# UNITED STATES PATENT AND TRADEMARK OFFICE

APPLICATION NO.	FILING DATE	FIRST NAMED INVENTOR	ATTORNEY DOCKET NO.	CONFIRMATION NO.
10/721,809	11/25/2003	Paul E. Salyer	SMI0100.US	6201

<b>Office Action Summary</b>	<b>Application No.</b> 10/721,809	<b>Applicant(s)</b> SALYER, PAUL	
	<b>Examiner</b> James L. Swiger	<b>Art Unit</b> 3733

## **DETAILED ACTION**

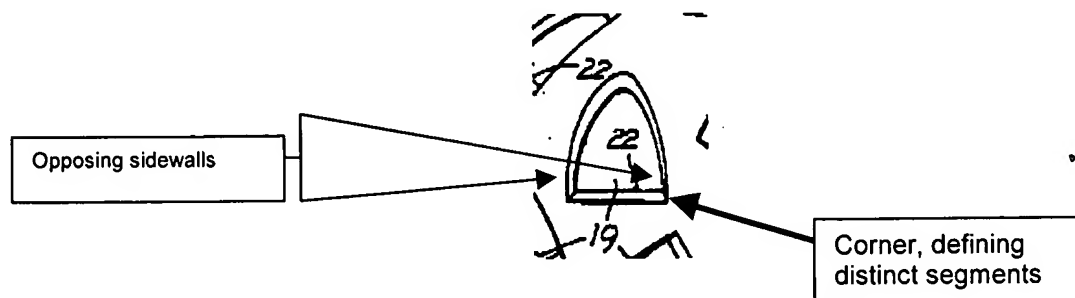
Claims 1-3, 5-6, 8-11, 13-19, and 16 are rejected under 35 U.S.C. 102(b) as being anticipated by Braun et al. (US 4,116,200). Braun et al. disclose a rotatable shaft (14), a cutting head with a plurality of teeth (Fig. 2), wherein each tooth comprises two opposing walls (segments 1 and 2) and corners that define three distinct segments, wherein 19 is the center segment. See drawing below.

Braun et al. further disclose a device wherein each segments has a radius which is less than the radius of the distal face (Col. 1, lines 55-68 through Col. 2, lines 1-5). The center segment is capable of having a radius greater than that of the corner segments. Braun et al. further disclose cutting teeth that have a ramped surface that extends between the cutting edge and the distal face and extends between the side walls (see Fig. 2, and 22). The cutting surface of the reamer is also generally hemispherical (see Fig. 3).
